LiDAR Quality Assessment Report

Materials Received: 12/27/2010	Project Type: ARRA Grant
Project ID: ARRA-WI_BrownCo_2010	Project Description: This lidar project consists of Brown County, Wisconsin and a portion of Oconto County, Wisconsin.
Project Alias(es): 	Year of Collection: 2010

Image for error?

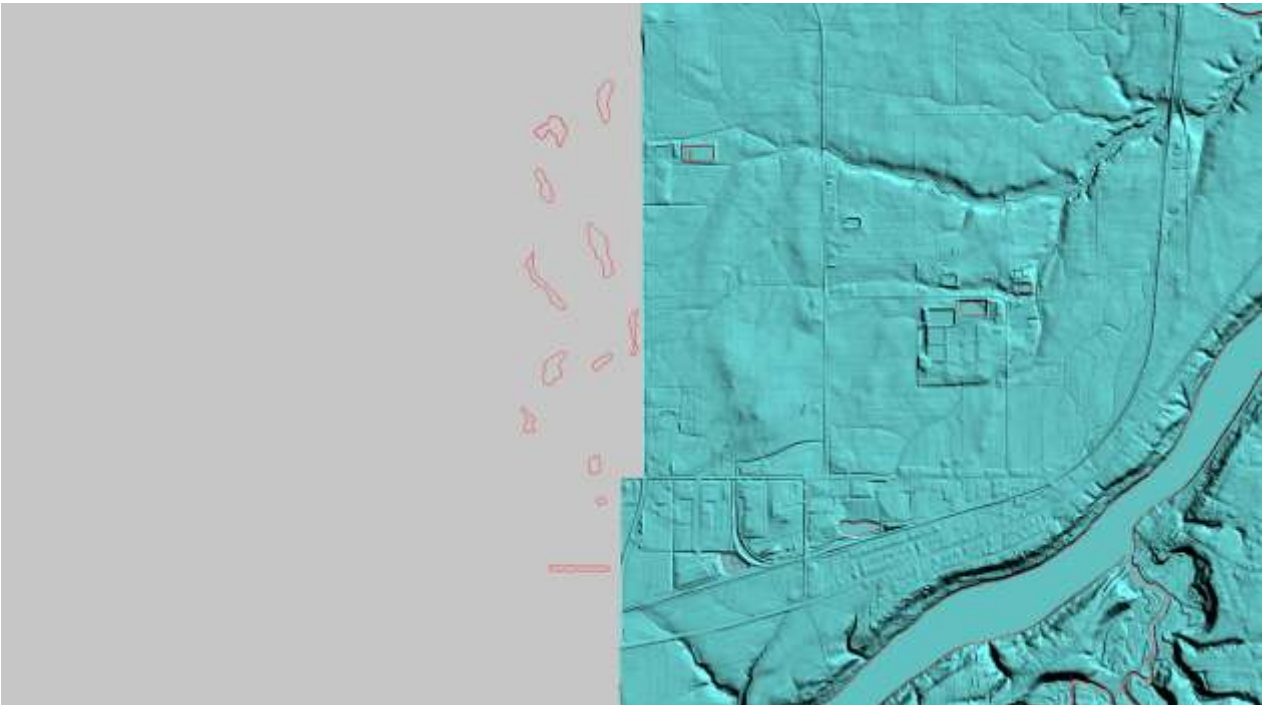
Breaklines (polygons and polylines) fall outside of the project boundary.

Image?

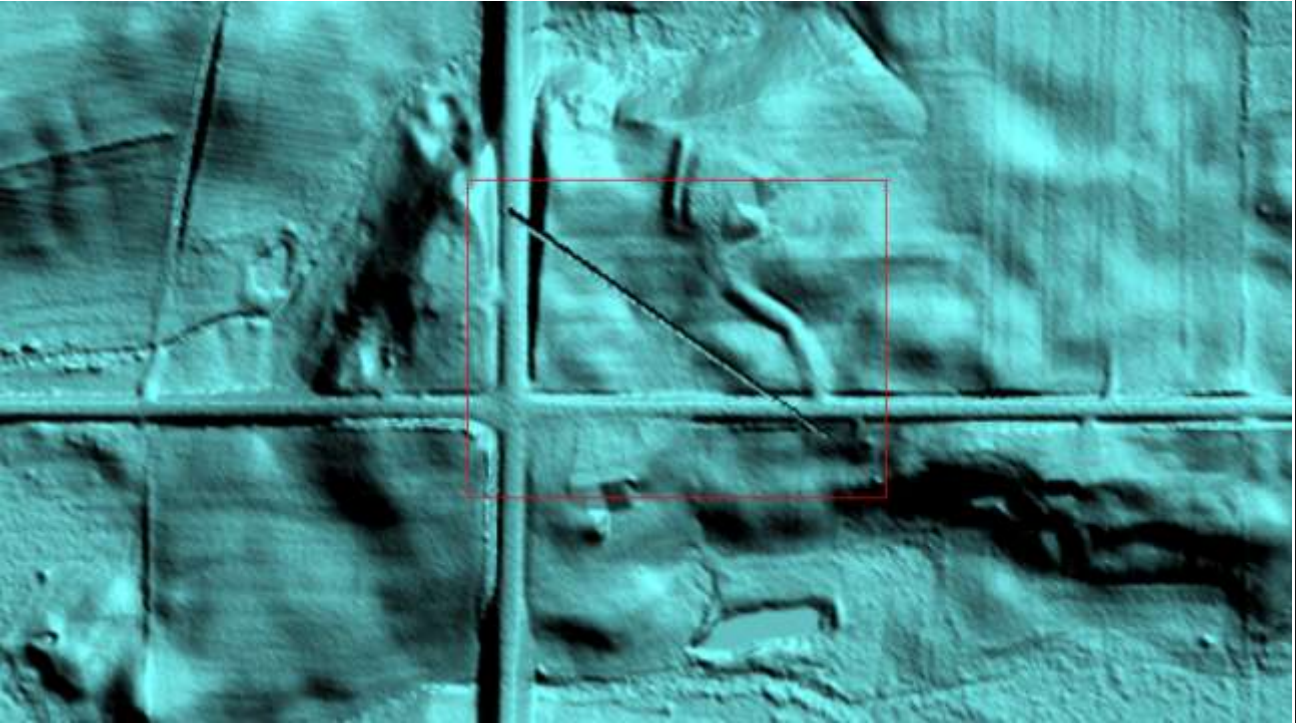
A "scar" which is present both in the DEM and DEM_Hydro_Flattened

The DEM_Appended consists of a single reviewable area, not multiple tiles like the other two datasets. Existing TINing in open-water and a main river channel, along with bridge-removal artifacts, were corrected by NGTOC personnel using Global Mapper by placing a "patch" over the affected areas.

Image?

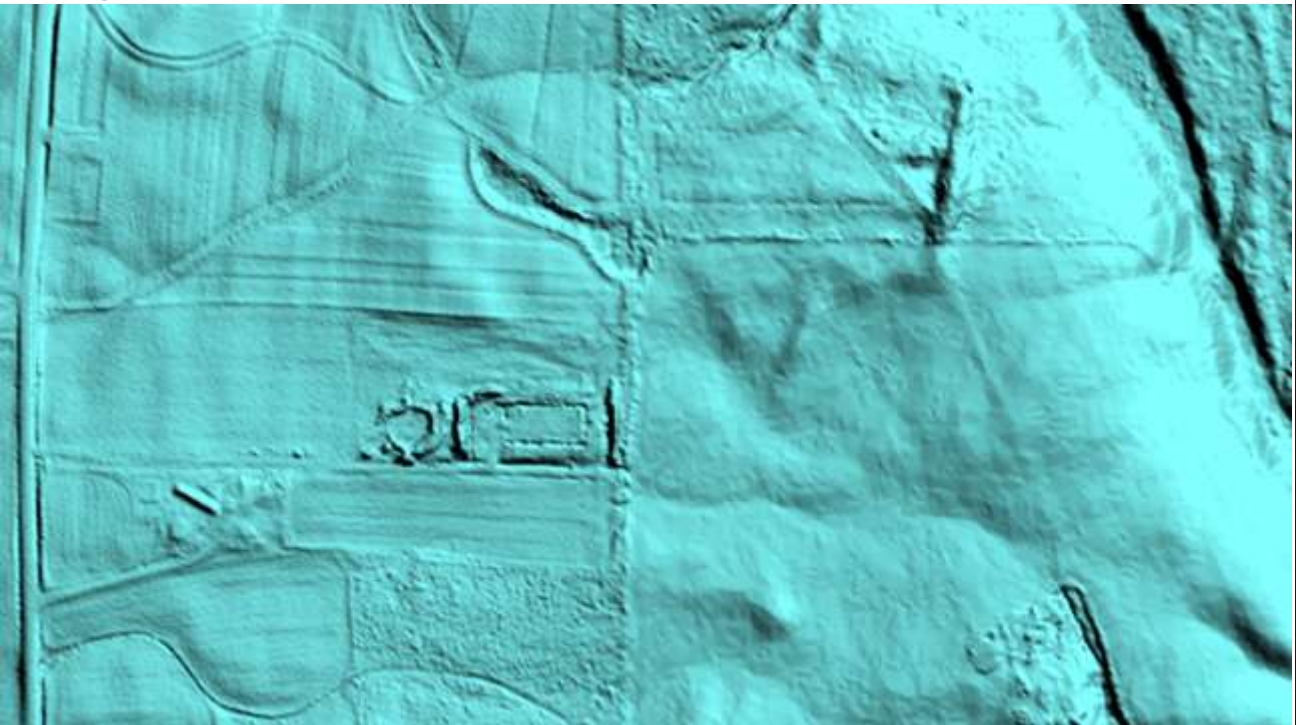
Large areas of TINing are present within the DEM and DEM_Hydro_Flattened.
